BUILDING PERMIT REPORT

DATE: 7/15/99 ADDRESS: 789 Brighton Ave CBL: 285-C-16

REASON FOR PERMIT: Build 8x12 Shed

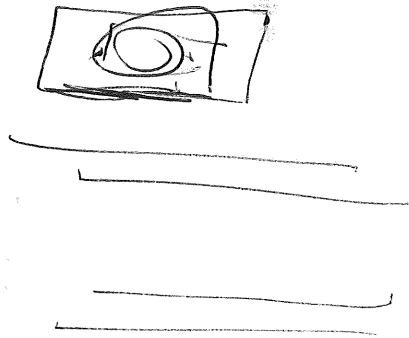
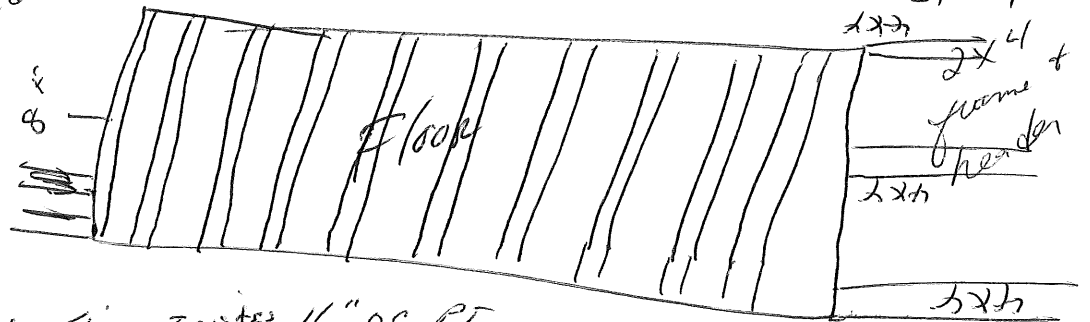
33. Glass and glazing shall meet the requirements of Chapter 24 of the building code.
34. The floor joists should be 2x8 construction for Any Significant weights that would stored in this shed
